- Subject: Engineering design change of 0.96" TFT
- Issue Date : April, 21<sup>th</sup> , 2022
- Description: In order to improve the problem of backlight warping and peeling when customers attach FPC to the back of the module, we have enhanced the backlight design and structure.
- Effect of Change : WF0096 and WJ0096 Series
- Appearance Difference : Yes
- Function Difference : No
- Planning Changing Time: Immediately

Before Change	After Change
Defect issue: WF0096 Mechanism LC and LB are easy to peel off and warp

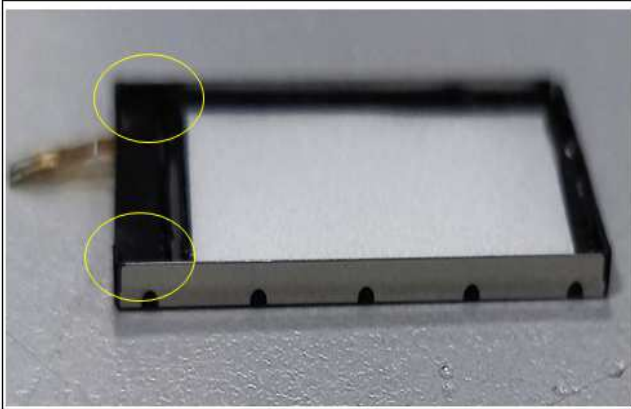
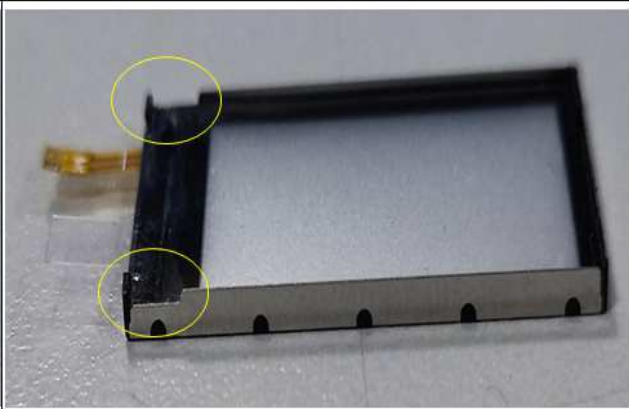
Original Backlight frame	Backlight frame shrink

Backside of Original Backlight frame	New Backlight Appearance

<p><b>Frontside Appearance</b></p>	<p><b>The frontside now has protection from shading tape; there is concave on the FPC.</b></p>

<p><b>Backside Appearance</b></p>	<p><b>The shading tape extends to the backside of the module.</b></p>
